City of Ketchum
Planning & Building

STAFF REPORT
KETCHUM PLANNING AND ZONING COMMISSION
REGULAR MEETING OF JULY 13th

PROJECT: North Pass No. 8 Townhouse Subdivision Preliminary Plat

FILE NUMBER: P20-041

Exhibit A:
Preliminary Plat

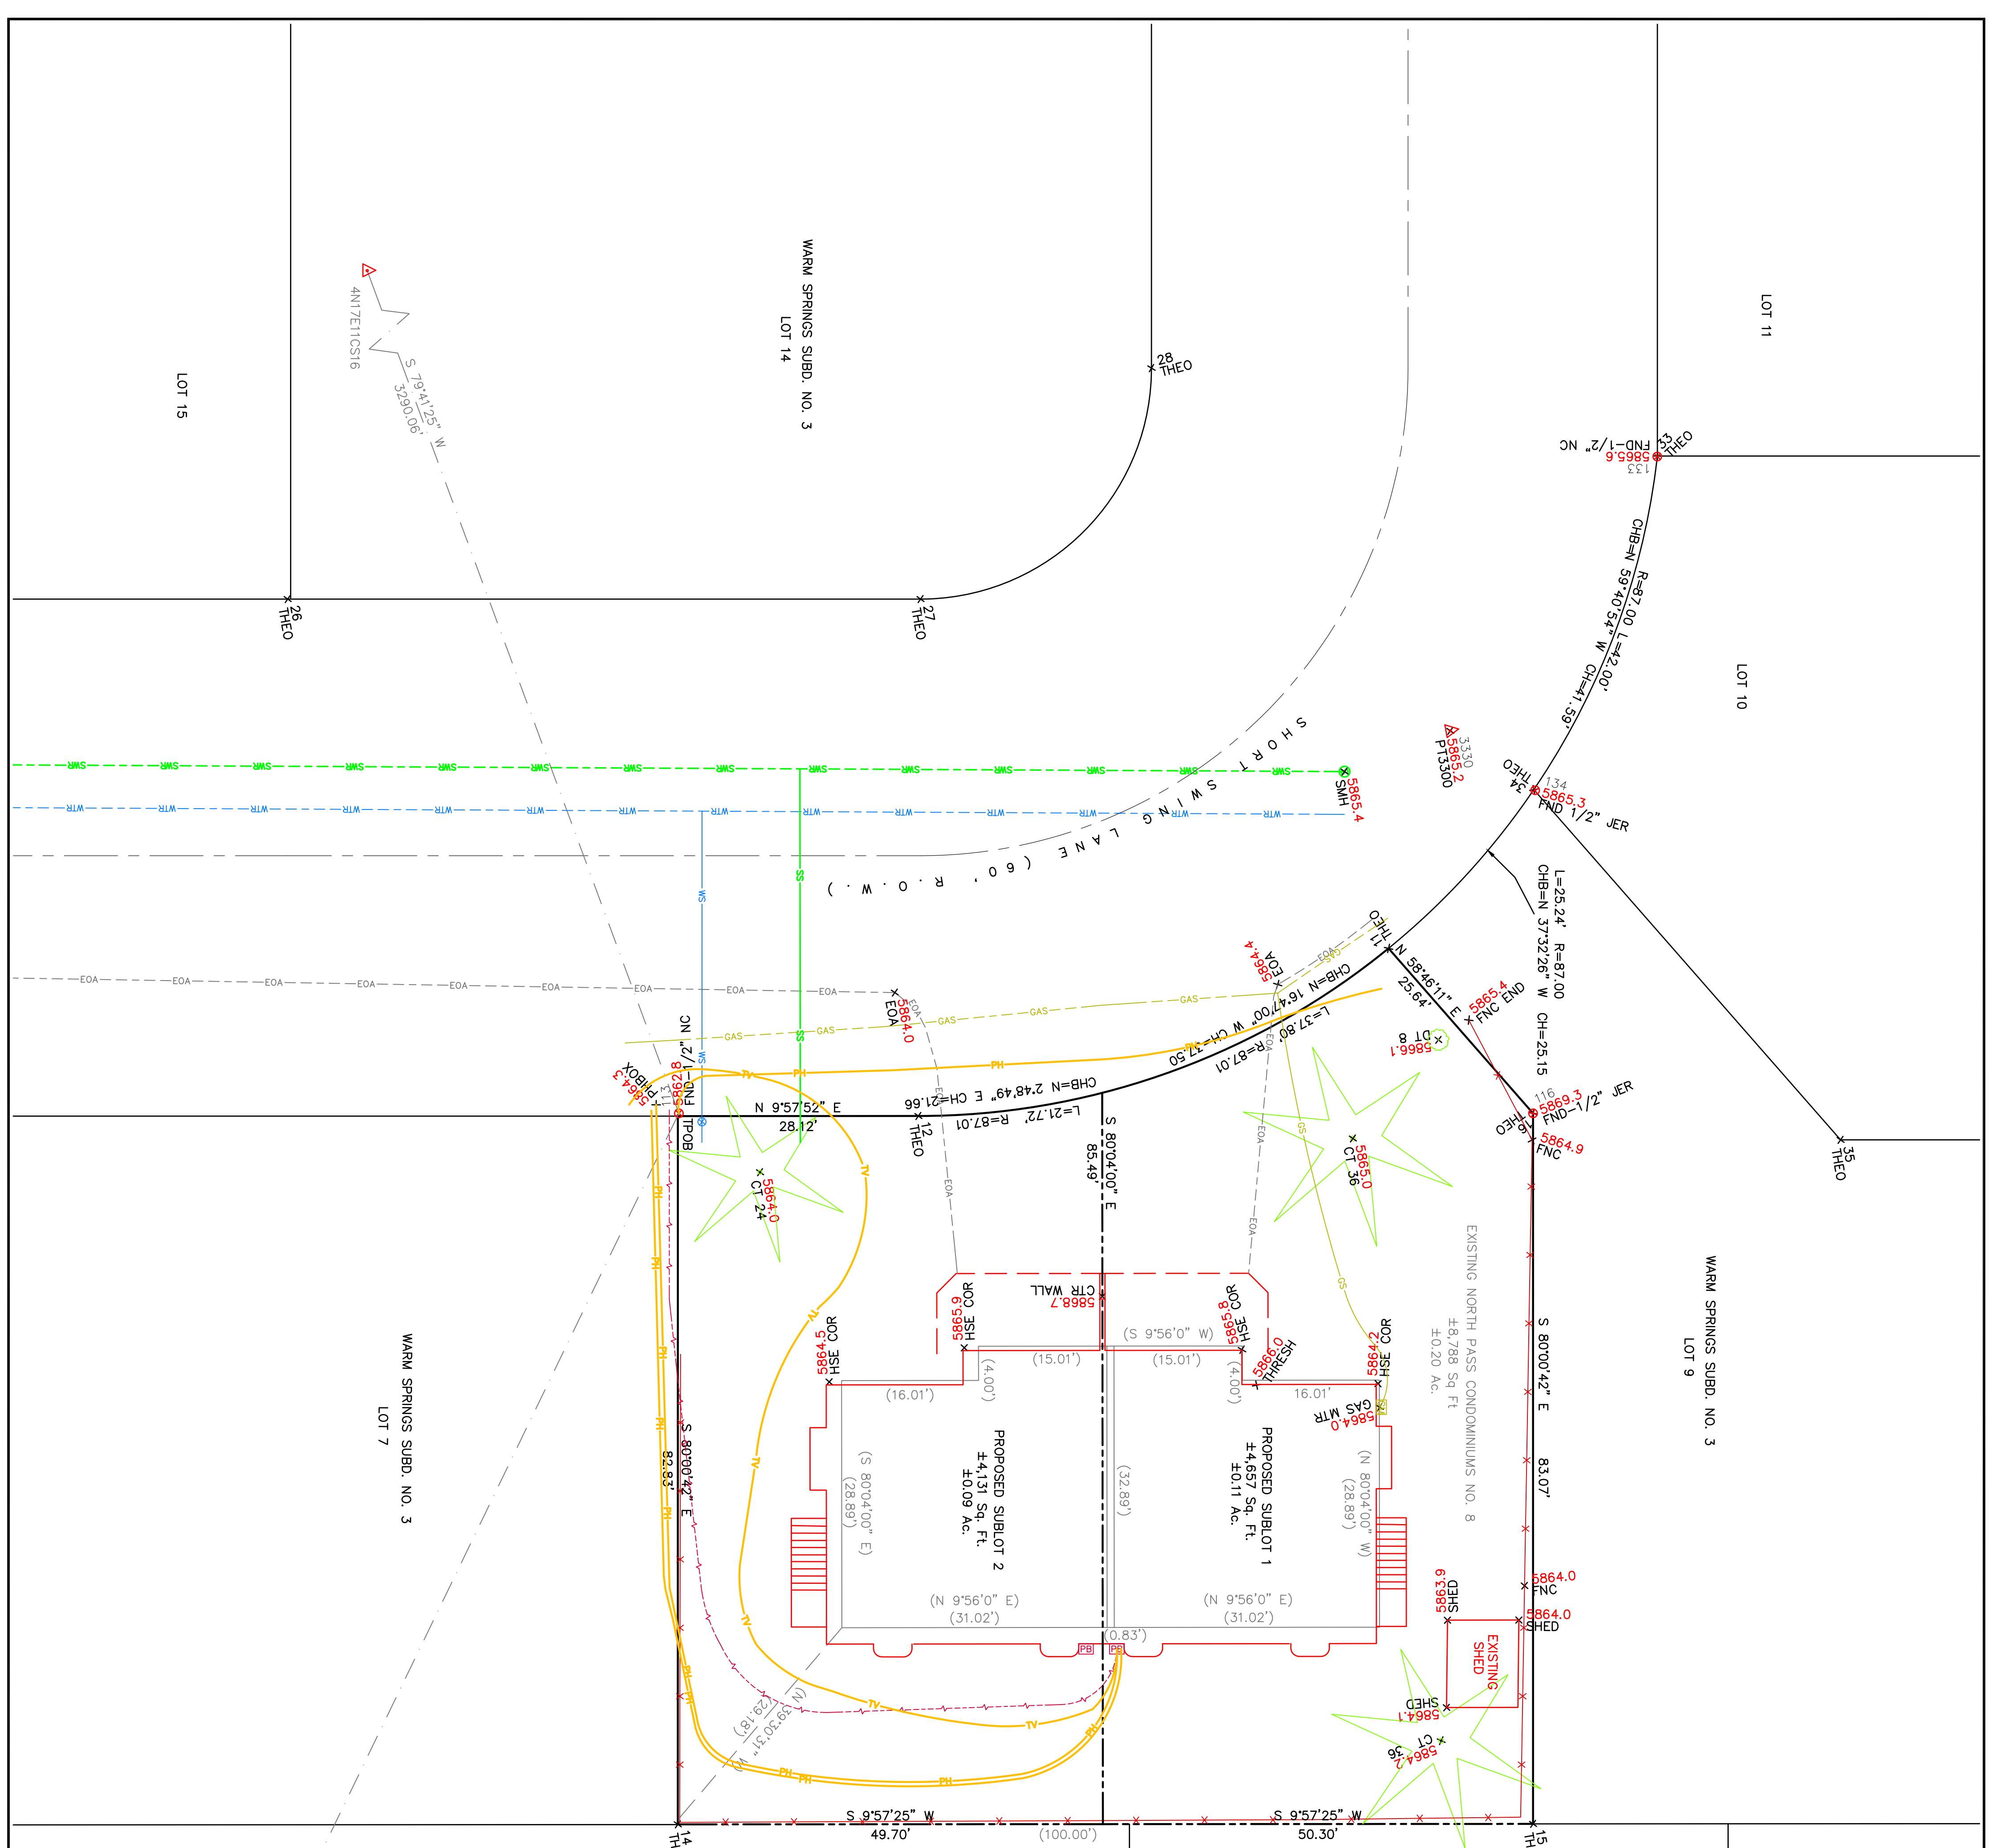
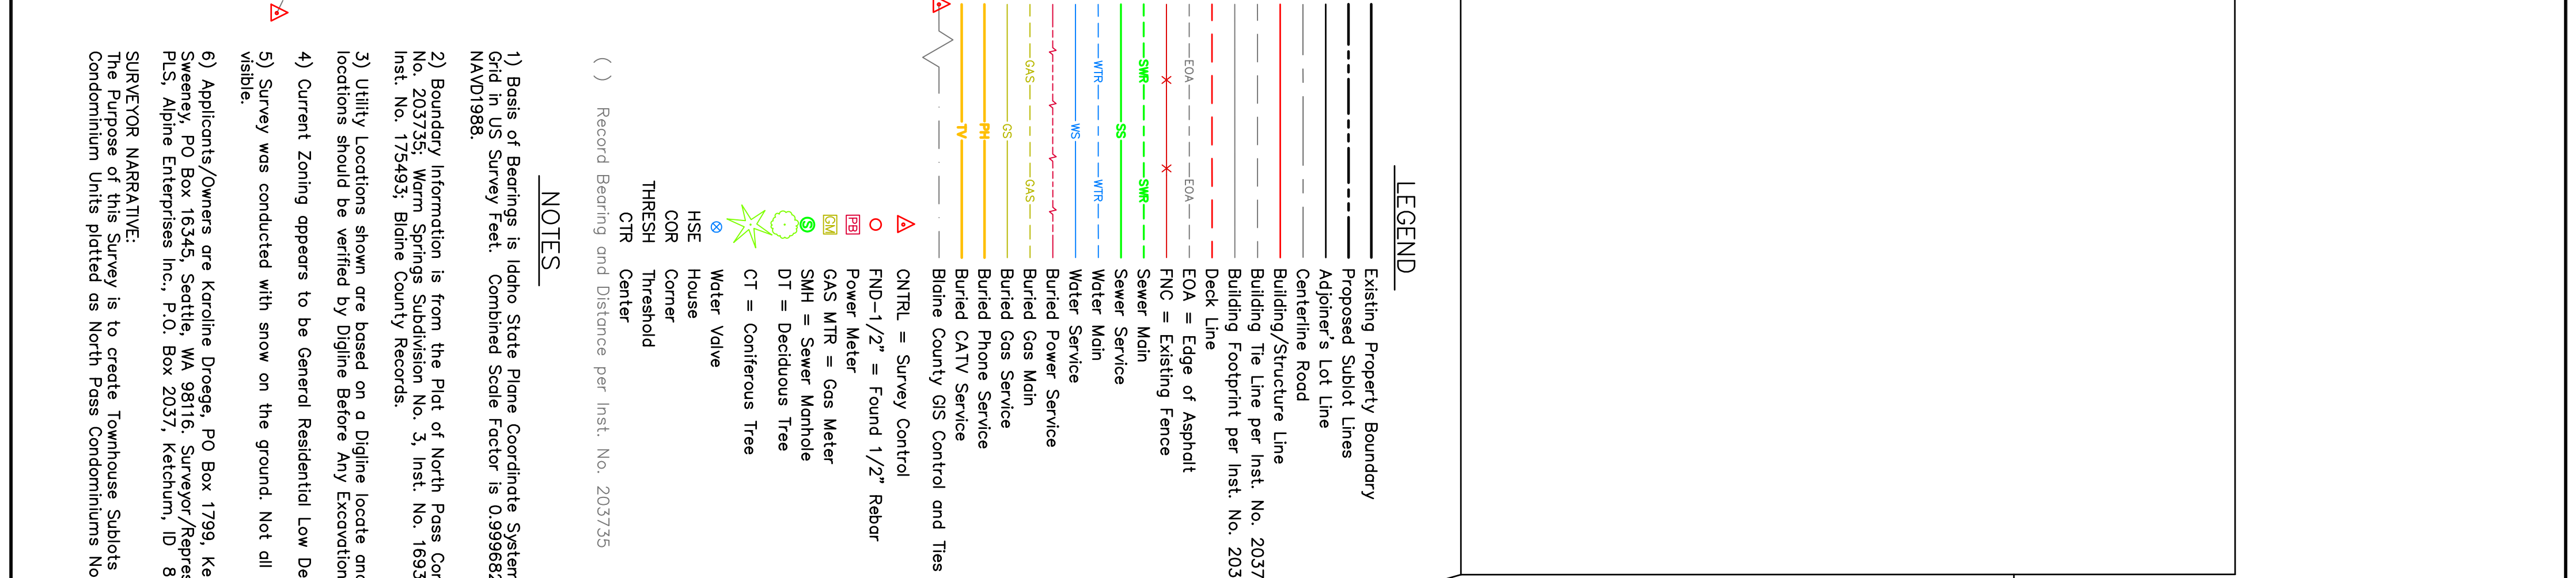
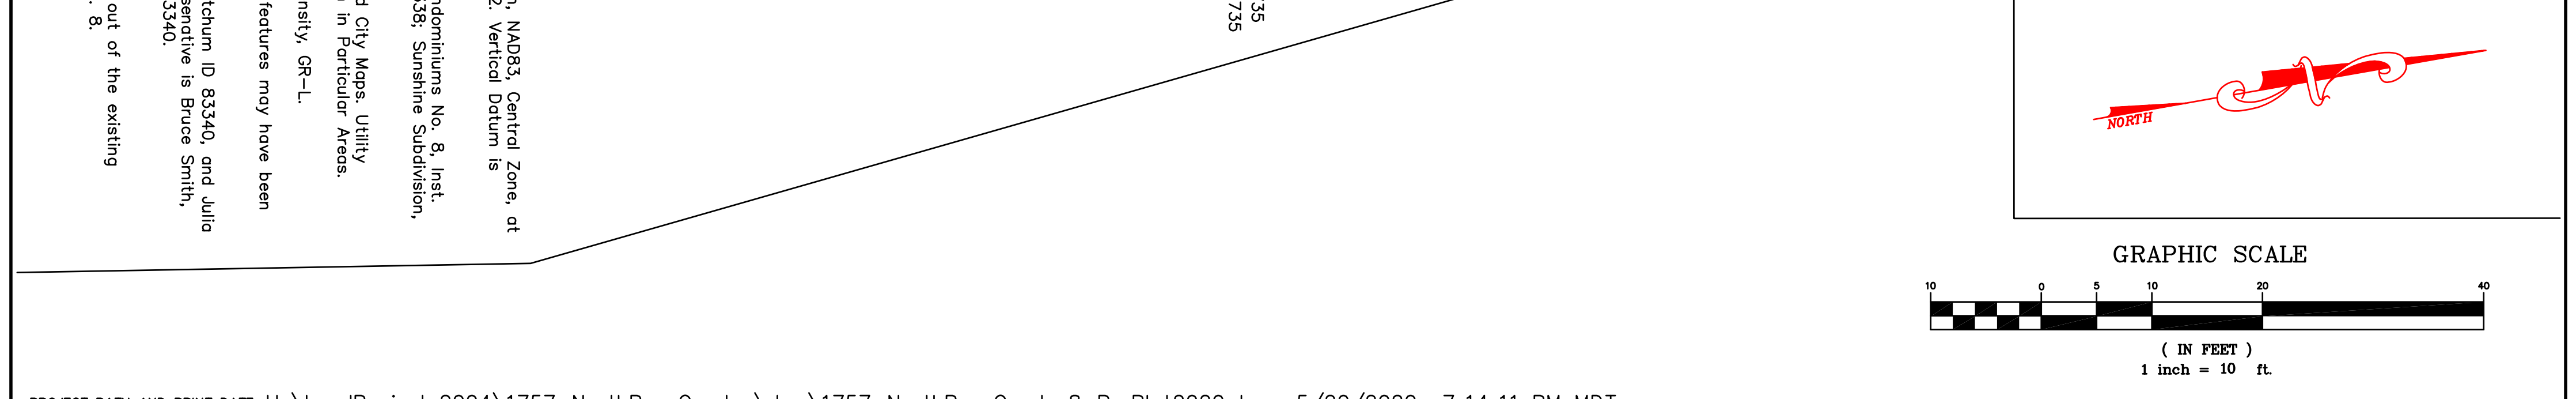
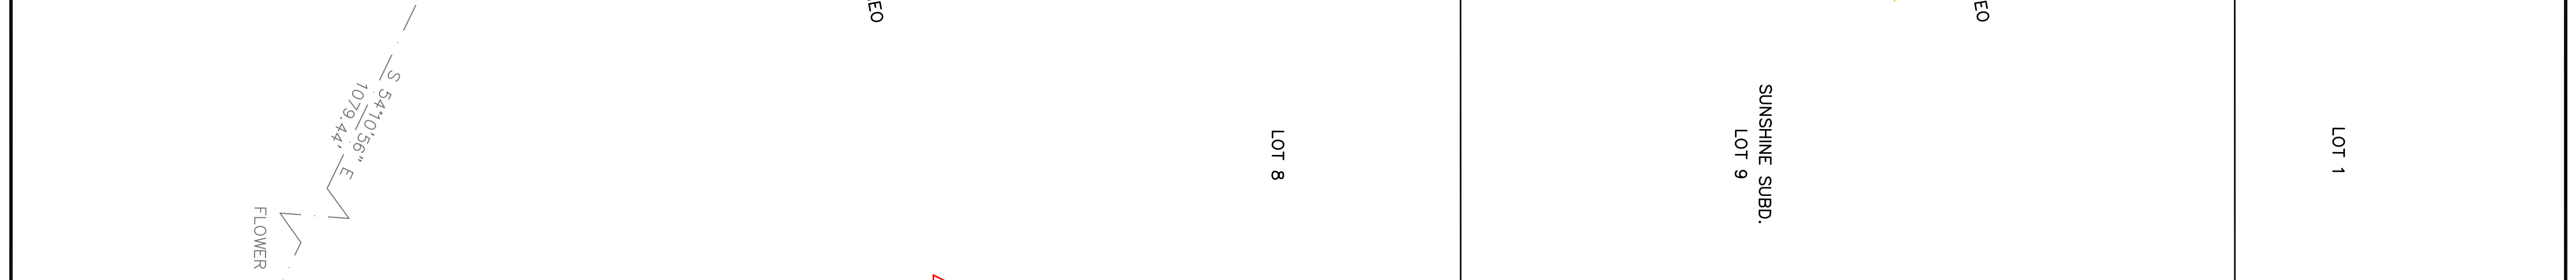
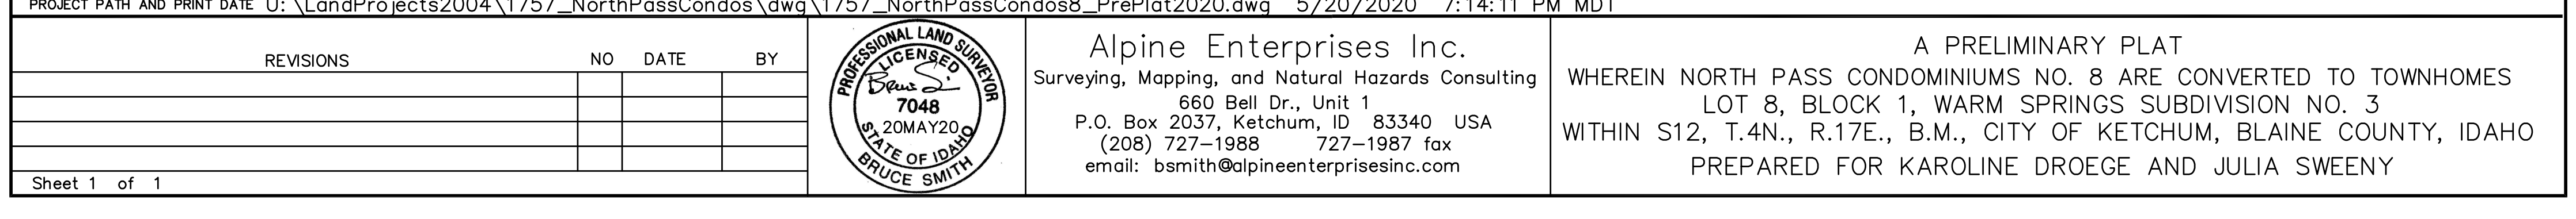
Findings	<i>This standard has been met. No new streets are proposed. The subplot lines and dimensions are indicated on the preliminary plat.</i>
<input checked="" type="checkbox"/>	<input type="checkbox"/>	<input type="checkbox"/>	16.04.030.J.11	The location, approximate size and proposed use of all land intended to be dedicated for public use or for common use of all future property owners within the proposed subdivision.
			Findings	<i>No land for common or public use is required or proposed.</i>
<input checked="" type="checkbox"/>	<input type="checkbox"/>	<input type="checkbox"/>	16.04.030.J.12	The location, size and type of sanitary and storm sewers, water mains, culverts and other surface or subsurface structures existing within or immediately adjacent to the proposed sanitary or storm sewers, water mains, and storage facilities, street improvements, street lighting, curbs, and gutters and all proposed utilities.

Findings	<i>The plat indicates the locations of all utilities that serve the townhome development. No street infrastructure improvements are proposed with this project.</i>
<input type="checkbox"/>	<input type="checkbox"/>	<input checked="" type="checkbox"/>	16.04.030.J.13	The direction of drainage, flow and approximate grade of all streets.
			Findings	<i>N/a as no new streets are proposed.</i>
<input type="checkbox"/>	<input type="checkbox"/>	<input checked="" type="checkbox"/>	16.04.030.J.14	The location of all drainage canals and structures, the proposed method of disposing of runoff water, and the location and size of all drainage easements, whether they are located within or outside of the proposed plat.
			Findings	<i>N/A. No drainage improvements are proposed with this subdivision.</i>
<input checked="" type="checkbox"/>	<input type="checkbox"/>	<input type="checkbox"/>	16.04.030.J.15	Vicinity map drawn to approximate scale showing the location of the proposed subdivision in reference to existing and/or proposed arterials and collector streets.

Findings	<i>The mature trees indicated on the preliminary plat shall be preserved.</i>
<input type="checkbox"/>	<input type="checkbox"/>	<input checked="" type="checkbox"/>	16.04.040.B	Improvement Plans: Prior to approval of final plat by the commission, the subdivider shall file two (2) copies with the city engineer, and the city engineer shall approve construction plans for all improvements required in the proposed subdivision. Such plans shall be prepared by a civil engineer licensed in the state.
			Findings	<i>N/A as no new improvements are proposed with this townhouse subdivision.</i>
<input type="checkbox"/>	<input type="checkbox"/>	<input checked="" type="checkbox"/>	16.04.040.C	Prior to final plat approval, the subdivider shall have previously constructed all required improvements and secured a certificate of completion from the city engineer. However, in cases where the required improvements cannot be constructed due to weather conditions or other factors beyond the control of the subdivider, the city council may accept, in lieu of any or all of the required improvements, a performance bond filed with the city clerk to ensure actual construction of the required improvements as submitted and approved. Such performance bond shall be issued in an amount not less than one hundred fifty percent (150%) of the estimated costs of improvements as determined by the city engineer. In the event the improvements are not constructed within the time allowed by the city council (which shall be one year or less, depending upon the individual circumstances), the council may order the improvements installed at the expense of the subdivider and the surety. In the event the cost of installing the required improvements exceeds the amount of the bond, the subdivider shall be liable to the city for additional costs. The amount that the cost of installing the required improvements exceeds the amount of the performance bond shall automatically become a lien upon any and all property within the subdivision owned by the owner and/or subdivider.

3. The recorded plat shall show a minimum of two Blaine County Survey Control Monuments with ties to the property and an inverse between the two monuments. The Survey Control Monuments shall be clearly identified on the face of the map.

8. Prior to the City Clerk's signature of final plat, smoke and carbon monoxide detectors shall be installed to meet current building code.
9. The following plat note shall be added to the Preliminary Plat prior to forwarding the application to City Council for review:

Although this unit was originally approved/constructed as a duplex in 1979, this duplex was converted to a non-conforming "Townhouse" pursuant to Ketchum Municipal Code § 16.04.070 TOWNHOUSES, insofar as the "Townhouse" is not in compliance with section R302.2 of the current International Residential Code, in effect at the date of this plat, and the City's local amendments to the building code specified in Ketchum Municipal Code §15.04.020, which requires a 2-hour fire-resistant wall assembly separation.
